**CORPORATION OF THE TOWNSHIP OF ESQUIMALT**

**DESIGN REVIEW COMMITTEE  
AGENDA**

## STAFF REPORT

**SUBJECT: REZONING APPLICATION**  
**1048 Tillicum Road**  
**[Lot D, Section 10, Esquimalt District, Plan 11683]**

4 SOUTH ELEVATION  
SK-3 SCALE= 1/8"=1'-0"

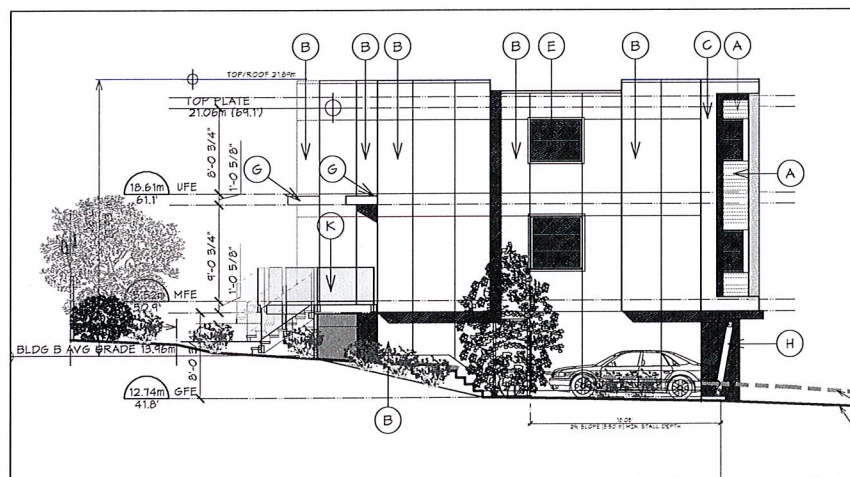
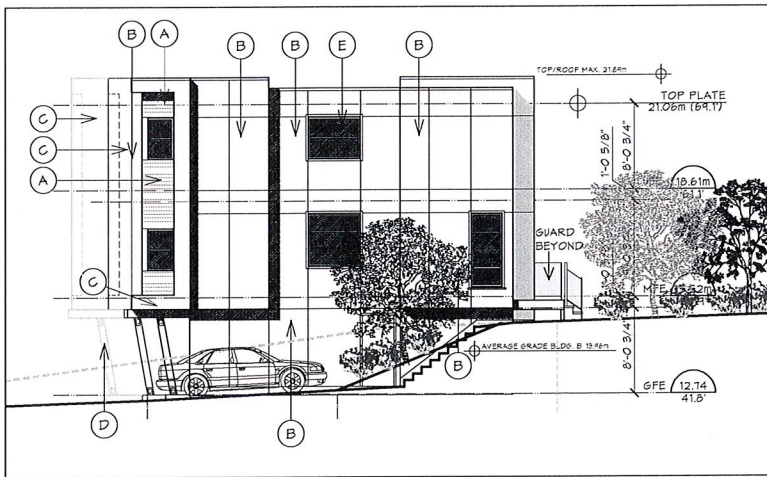
1. Reconsideration of the design of windows on the south side of Building B to address overlook of the neighbouring property to the south.
2. Reconsideration of design of the patio doors on Building A facing Tillicum appear more like front doors to the units.
3. Consideration be given to amending the site plan to provide access to the rear yard SRW.
4. Consideration be given to addressing traffic management concerns particularly regarding the left turn for this proposed development.
